ASSESSMENT REPORT

3 MURRAY ROSE AVENUE, SYDNEY OLYMPIC PARK MP 11_0082 MOD 2

Figure 2: Proposed Samsung business identification signage on the southern elevation (Base source: proponent's application)

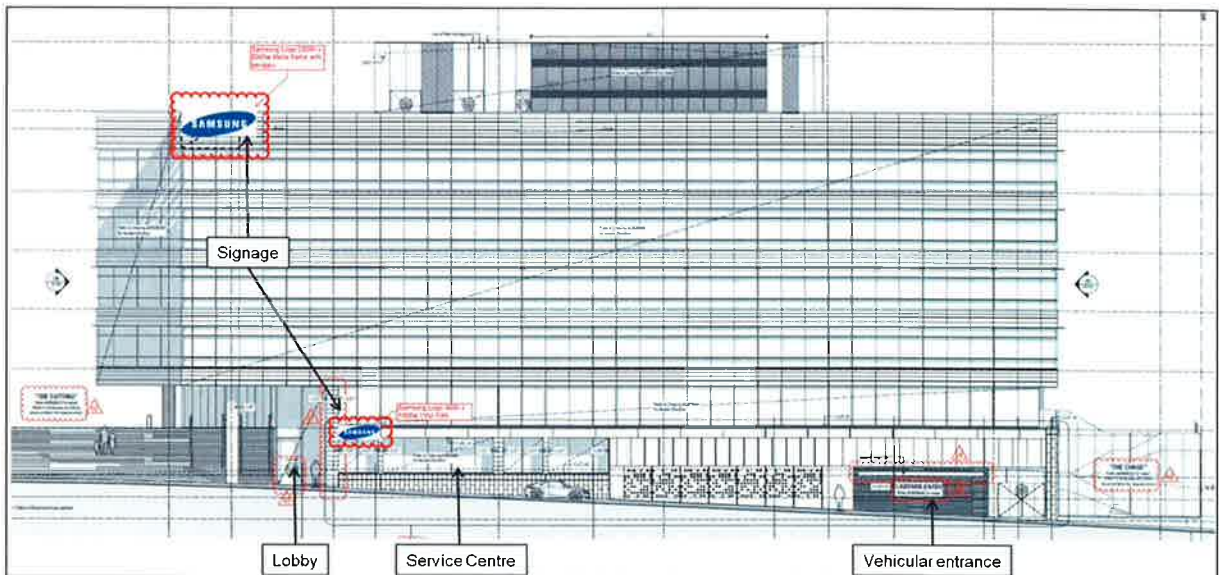
- the gradient of the access ramp to the bicycle parking should not exceed 25%; and
- the upper level sign on the northern elevation (sign number six) should be deleted to reduce the impact on the adjacent parkland and to be consistent with the adjacent building at 5 Murray Rose Avenue.

SOPA raised concerns that the total number of signs was excessive and recommended that the parapet level sign (2500mm x 500mm) on the northern elevation facing the parklands (Brickpit Park) be deleted.

The proponent has confirmed that it has no objection to the removal of the parapet level sign on the northern elevation.

Subject to the removal of the sign on the northern elevation, the Department considers that the proposed signs on all other elevations are acceptable as they:

The Department recommends that the proposed northern elevation plan (which includes the parapet level sign to be removed, as discussed above) not be included as part of the updated drawing list at condition A2. The Department also recommends a new condition that requires the signage to comply with appropriate design and maintenance standards.

Figure 3: Approved (top) and proposed (bottom) lower ground floor layout (Base source: proponent's application)

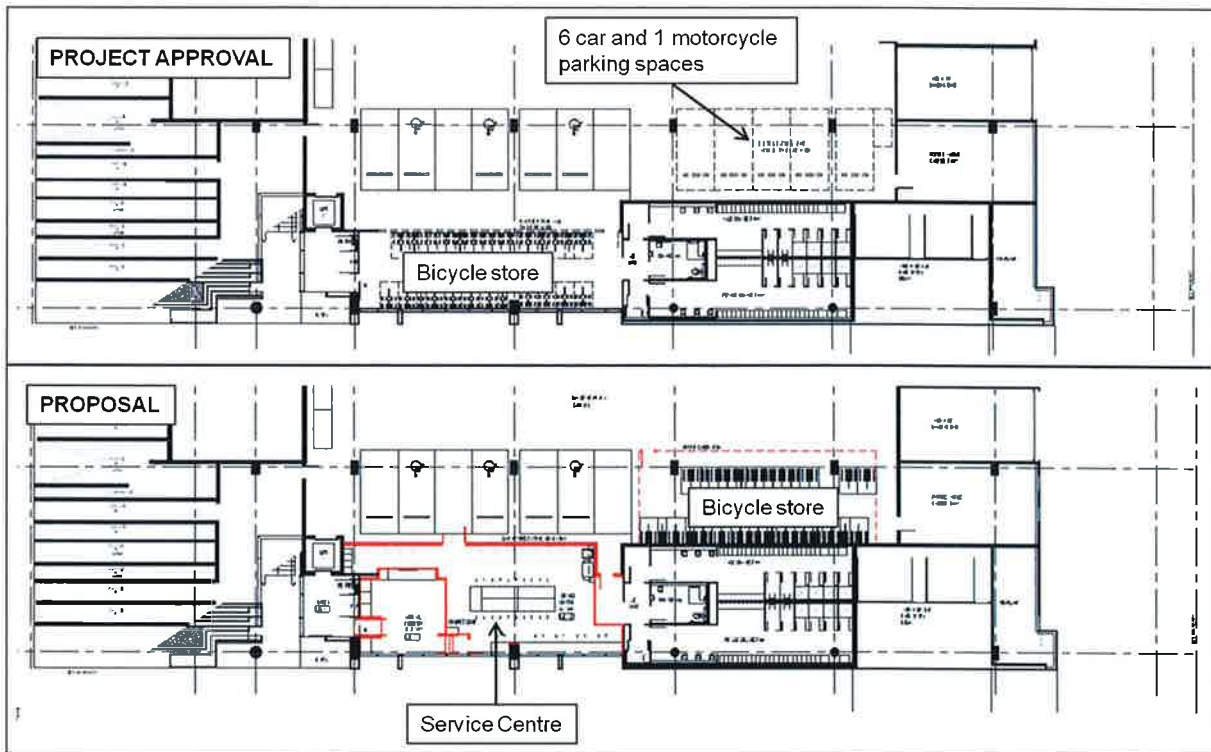
SOPA supported the proposed provision of the service centre. However, SOPA suggested that the gradient of the vehicular access ramp should not exceed 25% to ensure ease of access for cyclists.

The Department considers that the proposed provision of the service centre and associated alterations to the lower ground floor level are acceptable for the following reasons:

- the provision of a service centre fronting Murray Rose Avenue would provide for street level activation and passive surveillance of the Murray Rose Avenue frontage;
- the proponent has confirmed that the gradient of the vehicular access ramp is less than 25%;
- the relocation of the bicycle store and revised access arrangements would not impede the use of the bicycle store;
- the bicycle store is conveniently located in close proximity to end of trip facilities, lifts and stairs;

- the reduction of six car parking spaces (from 249 to 243 spaces) is minor in the context of the total number of car parking spaces provided. Furthermore, as concluded in the Department's assessment of the original application, the site well served by public transport;
- the Transport Impact Assessment submitted with the application states that the traffic generated by customers visiting the service centre is anticipated to be minor (i.e. less than 10 vehicles per hour) and typically during the day (outside peak periods); and
- the fit out of the service centre is acceptable.

The Department recommends that condition B6 'Number of Car Spaces' be amended so that it reflects the modified total number of car parking spaces discussed above. The Department also recommends that Term of Approval A7 be amended to make reference to the service centre fit out.
